**AMB's Questions and Comments on Revised Catch Application  
for Special Exception Case 2025-5  
June 20, 2025**

**Special Exception (Town of Warner Zoning Ordinance Article XVII E.)**

1. A Special Exception is required for the **revised** CATCH proposal to construct a 34 unit multi-family workforce housing development in the C-1 district and the Intervale district.

## PRESENTATION PLAN

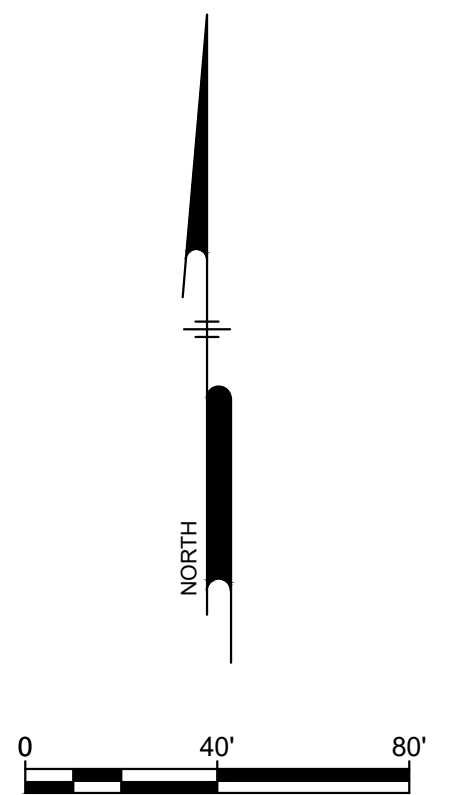
- d. Previous plans filed by the current property owner, Comet LLC with the Warner Planning Board for Map 35, Lot 4-3 did not include a stormwater pond. See attachments labeled Comet LLC 2022-08-08\_PLAN SET-1 and 2022-08-29\_PRESENTATION PLAN Sheet 5 of 20.

18. The viability of a 24 unit multi-family workforce housing project is clearly demonstrated by the previous plans filed by the current property owner. See attachments labeled Comet LLC 2022-08-08\_PLAN SET-1 and 2022-08-29\_PRESENTATION PLAN Sheet 5 of 20.
